**SUBJ:** Equipment/Furnishings – First Observer’s Seat Cup Holder

This Special Airworthiness Information Bulletin is to advise registered owners and operators of **The Boeing Company Model 737-600, -700, -700C, -800, -900, and -900ER series airplanes, and Model 737-8 airplanes, with line numbers 1 through 6,640 inclusive**, of the potential for the cup holder of the First Observer’s seat to be inadvertently removed.

Figure 1 – First Observer’s Seat

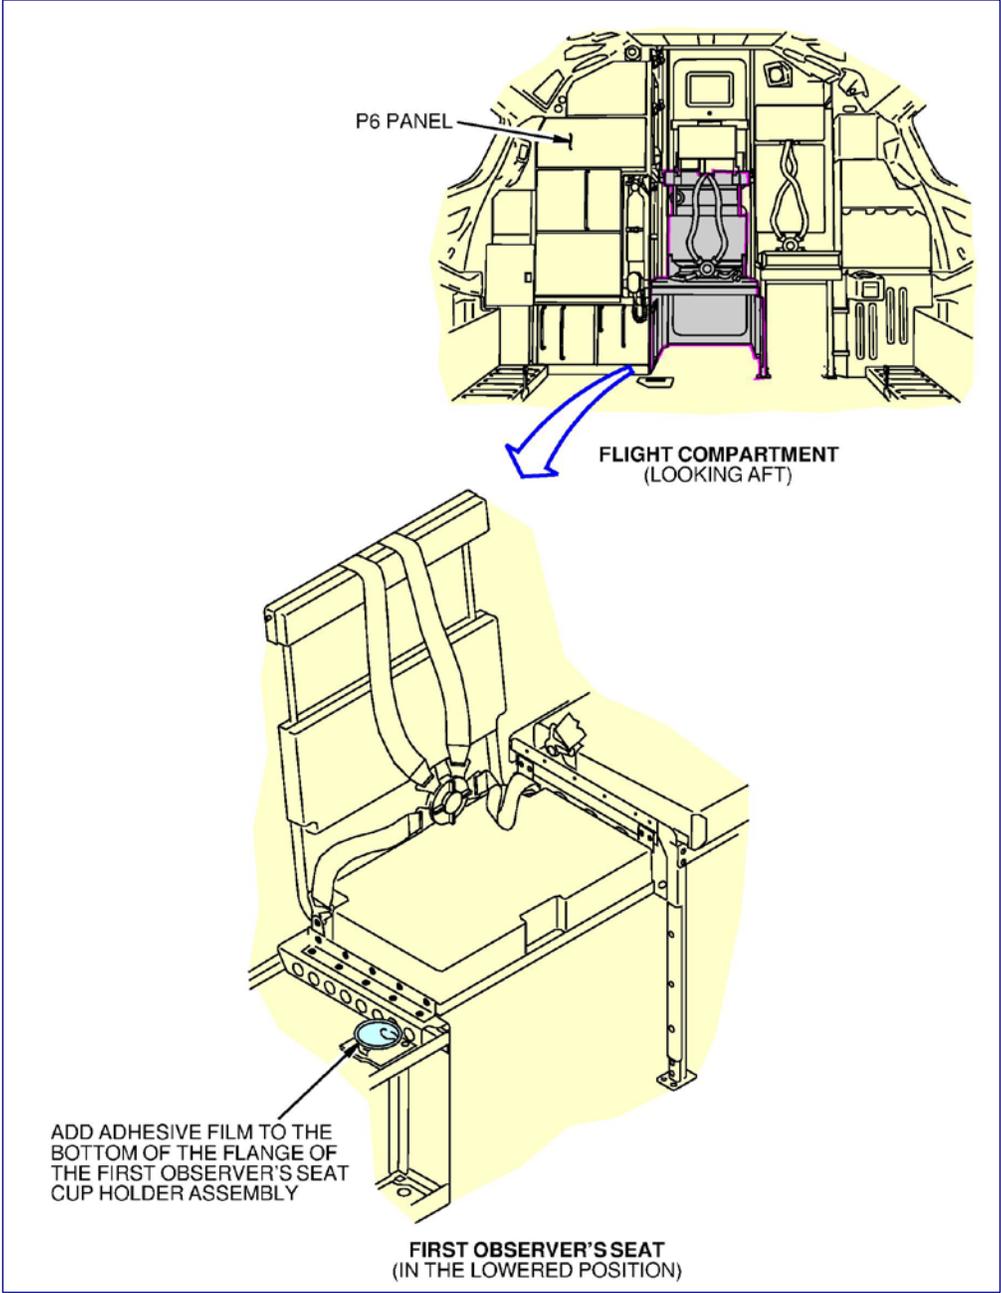
An operator informed us about a cup holder which stuck to a cup and was inadvertently discarded with the cup. This created an open hole, exposing the P6-11 circuit breaker panel just below the cup holder (see Figure 1). The P6-11 circuit breaker panel contains some of the airplane's primary electrical power circuit breakers. Spilling liquid or dropping something metal into the open hole could result in a short circuit of primary electrical power systems during flight.

Boeing has issued Service Bulletins 737-25-1790 (for Model 737-600, -700, -700C, -800, -900, and -900ER series airplanes), and 737-25-1791 (for Model 737-8 airplanes). This service information provides procedures to secure the cup holder by adding adhesive film to the bottom of the cup holder flange. This improves the retention force to prevent unintended removal of the cup holder.

The FAA recommends that all owners and operators of the affected airplanes improve the safety of their aircraft by incorporating the instructions in the applicable service information at the earliest opportunity. The design change was incorporated in production on airplanes manufactured after line number 6,640, so those airplanes are not affected.
